**ADDENDUM no. 2 to the
FINAL ENVIRONMENTAL IMPACT REPORT/ENVIRONMENTAL ASSESSMENT for
the
U.S. HIGHWAY 50/EL DORADO HILLS BOULEVARD-LATROBE ROAD
INTERCHANGE PROJECT**

AUGUST 2008

Project Title: U.S. Highway 50/El Dorado Hills Boulevard-Latrobe Road Interchange
EIR/EIS ADDENDUM no.2

FIGURE B

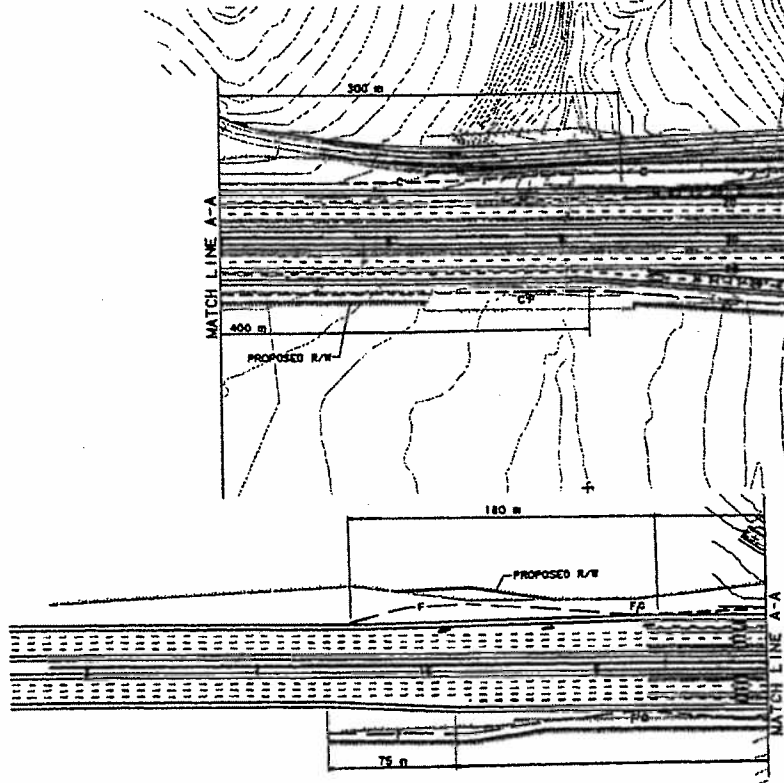
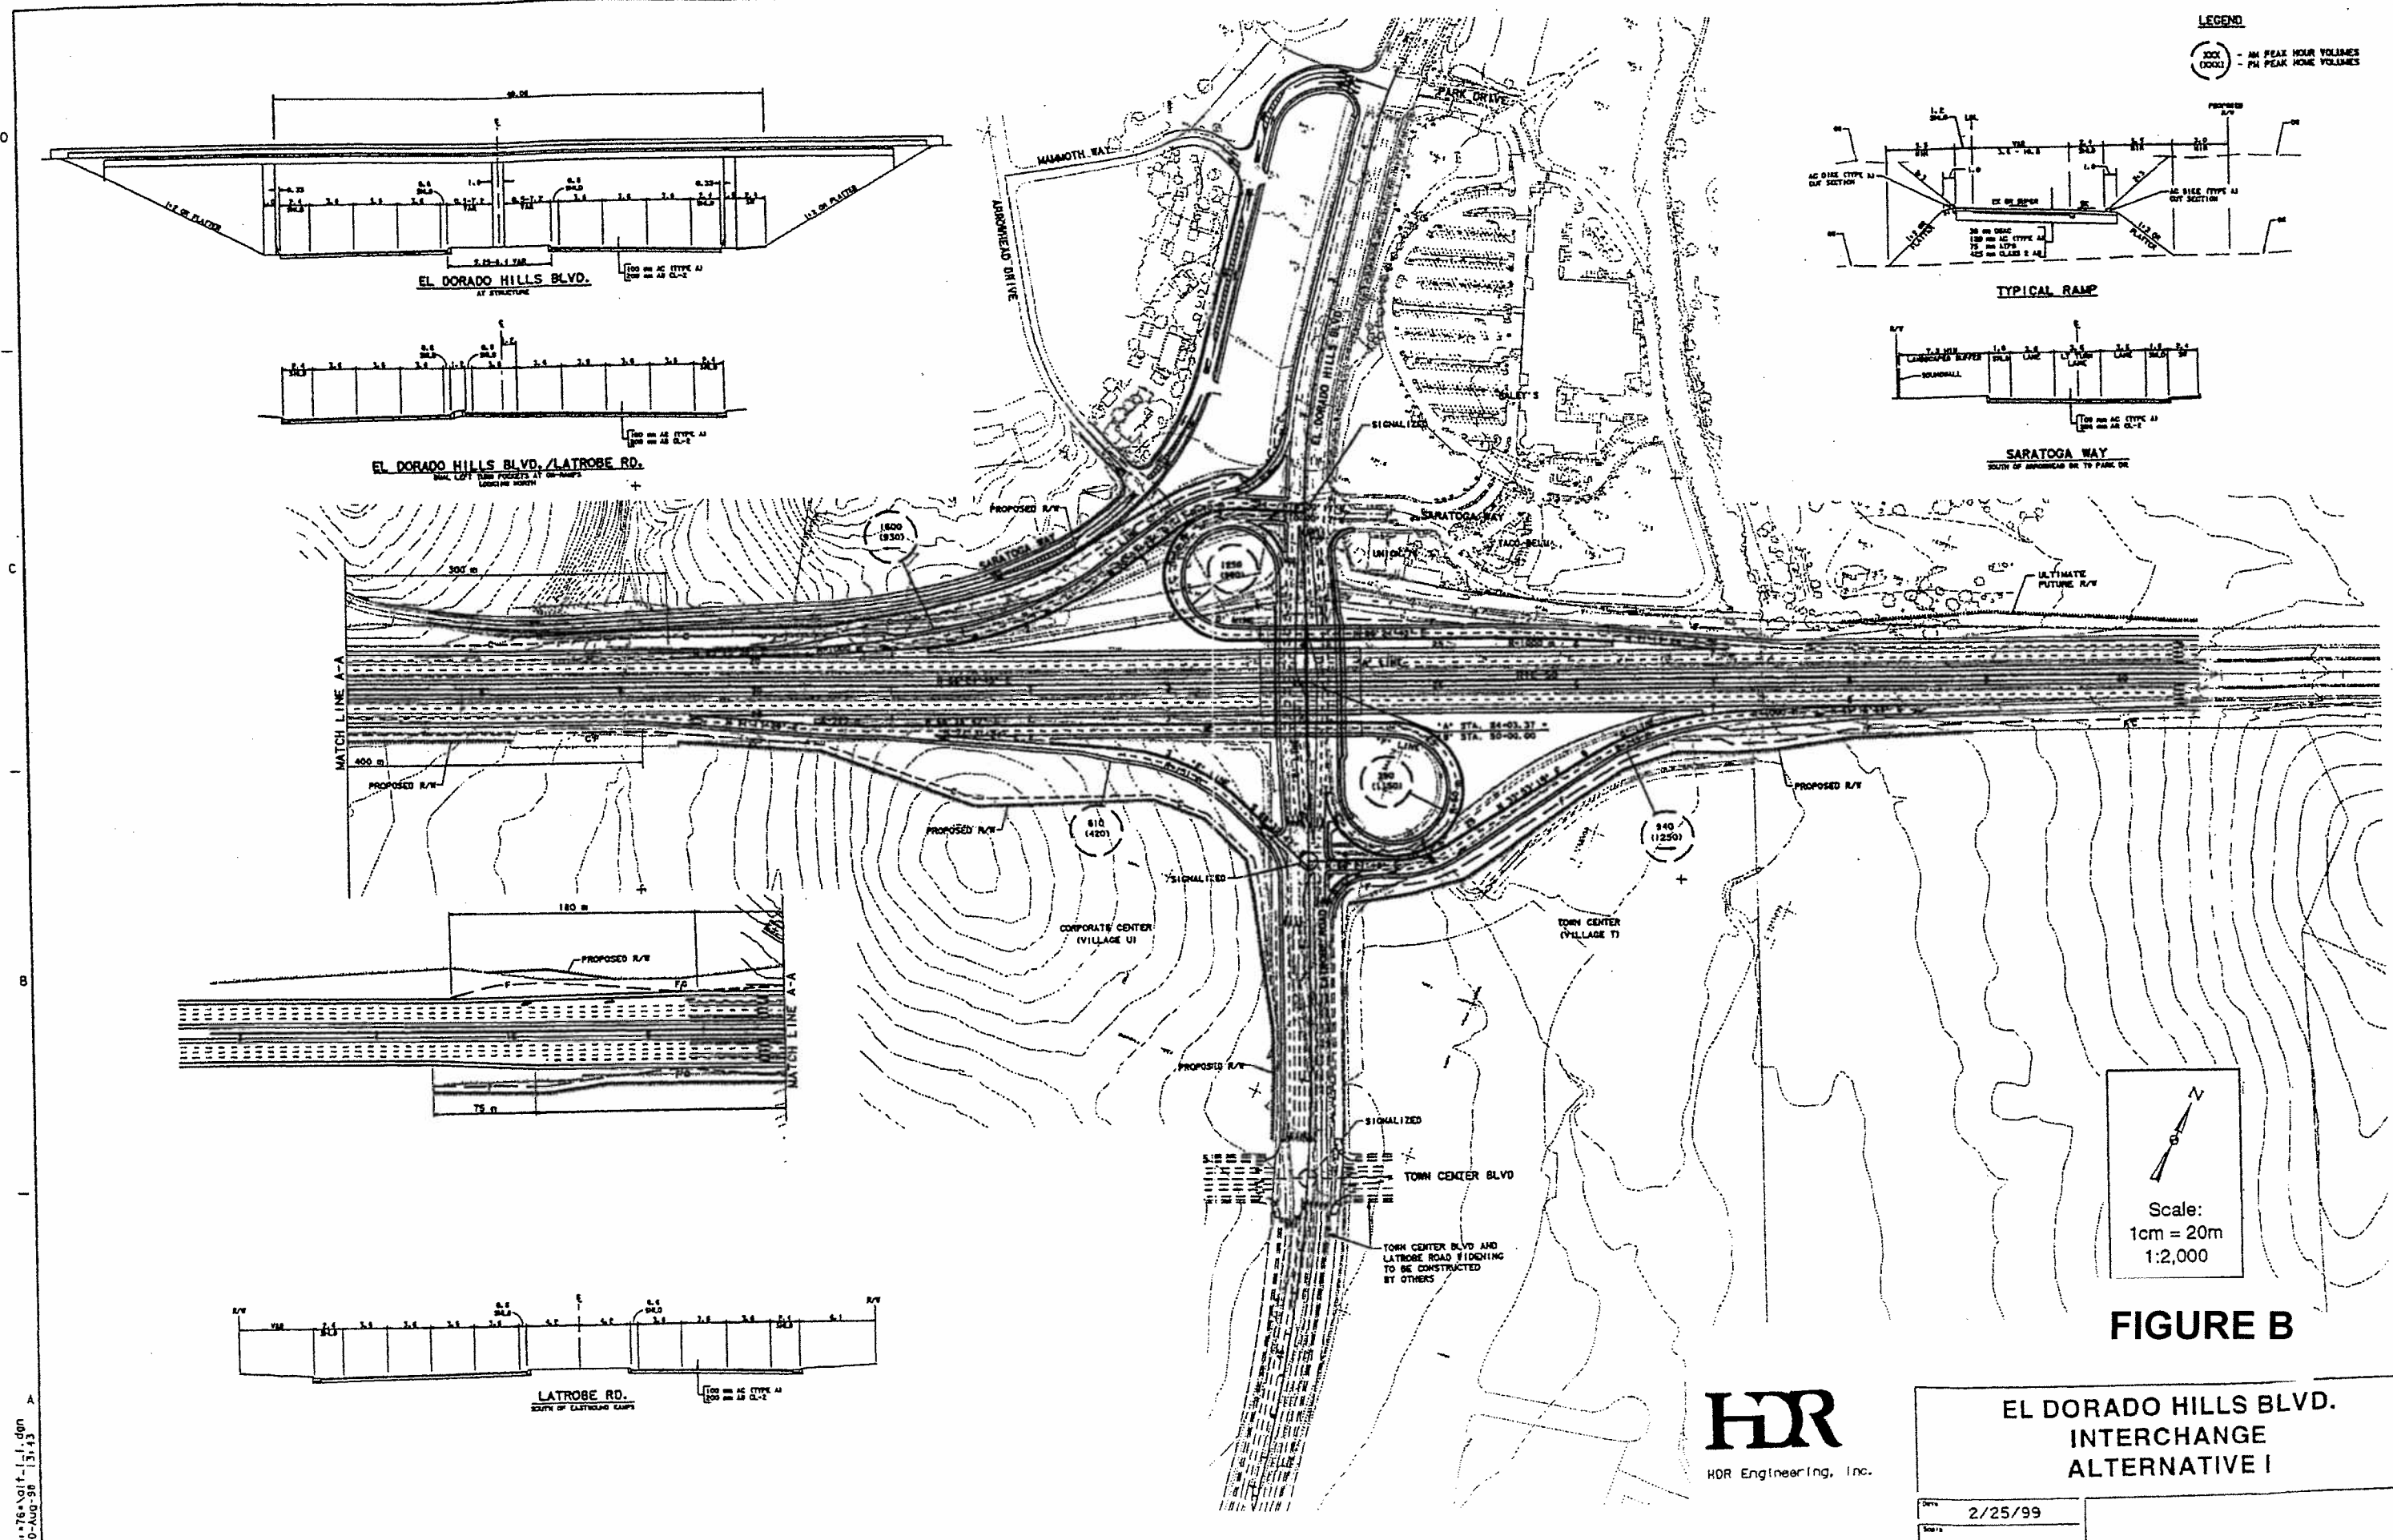
In the proposed project the alignment of the EB off-ramp will be modified from the ultimate configuration in the EIR/EA, shown in Figure B, to an interim condition as shown in Figure J in order to align the ramp with the replacement bridge. This interim phase does not include lengthening and widening (to 2 lanes) the eastbound to southbound off-ramp due to funding limitations. The ramp will remain a single lane instead of 2 lanes and the gore point will occur between the existing and ultimate gore points for the interim condition. This results in a shorter, narrower ramp for the interim condition. The ramp will remain a dedicated ramp for northbound El Dorado Hills Blvd traffic for the interim condition. The ultimate EB ramp alignment will be constructed in Phase 2B per the EIR/EA, as shown in Figure B.

FIGURE C

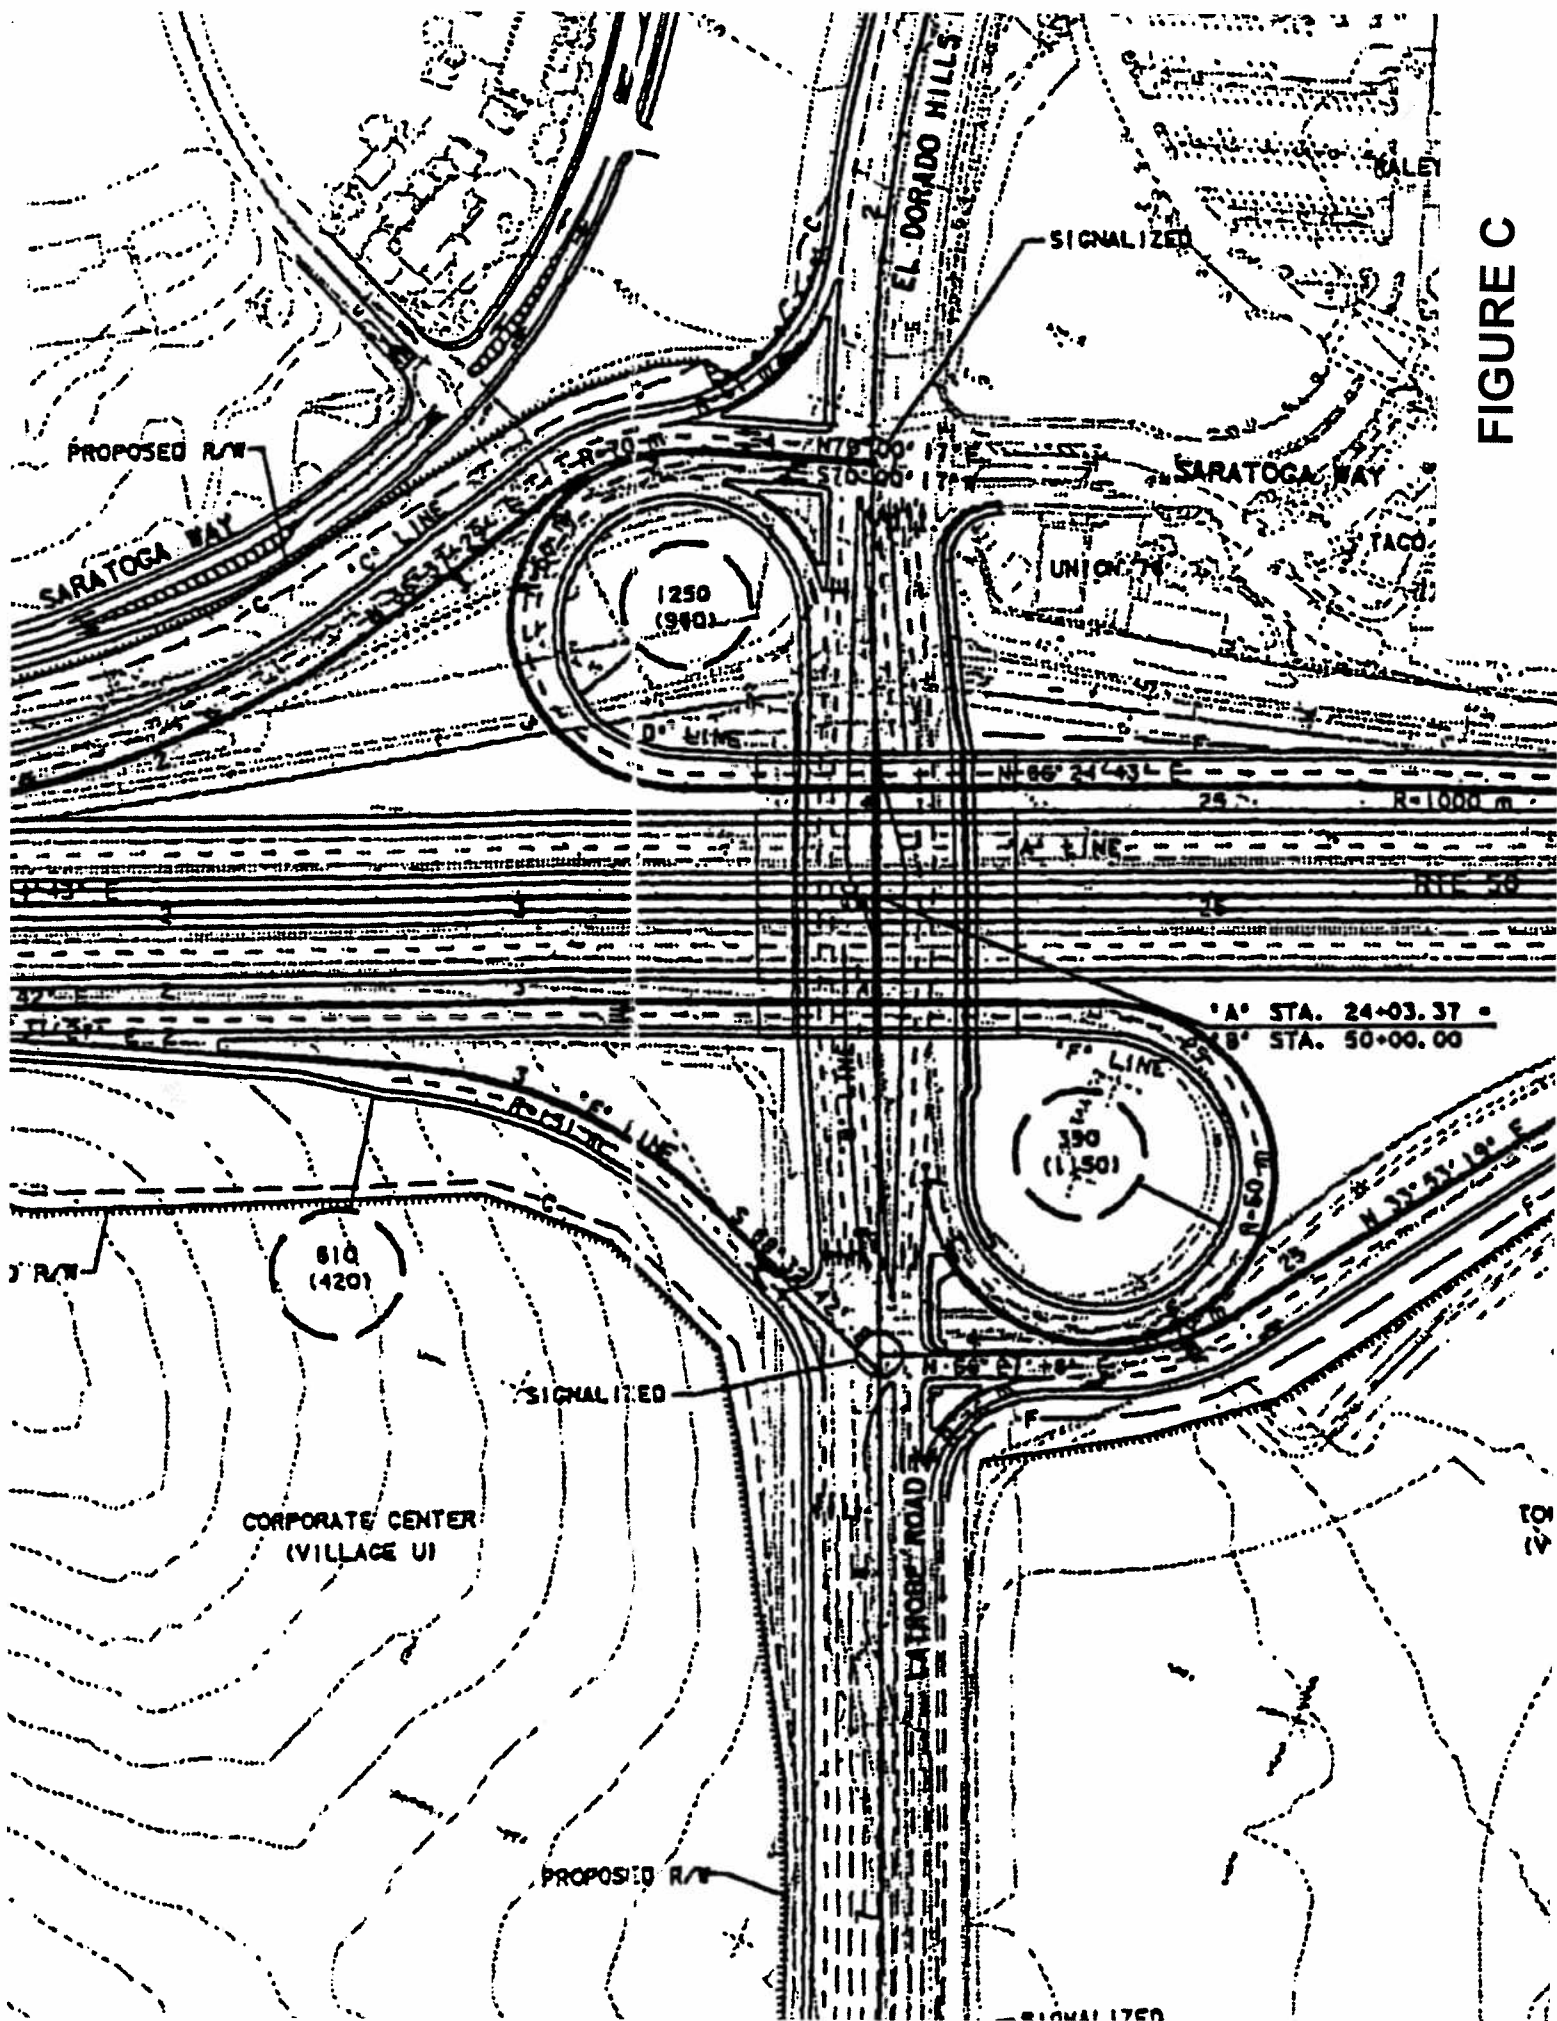
The approved project included the construction of three through lanes and two dedicated left-turn lanes on the northbound and southbound sections of El Dorado Hills Boulevard/Latrobe Rd beneath the bridges and approaching the adjacent intersections with the Hwy 50 ramps as shown in Figure C, which is an enlargement of Figure B. Phase 2A proposes to construct, as an interim condition, the lanes shown in Figure D.
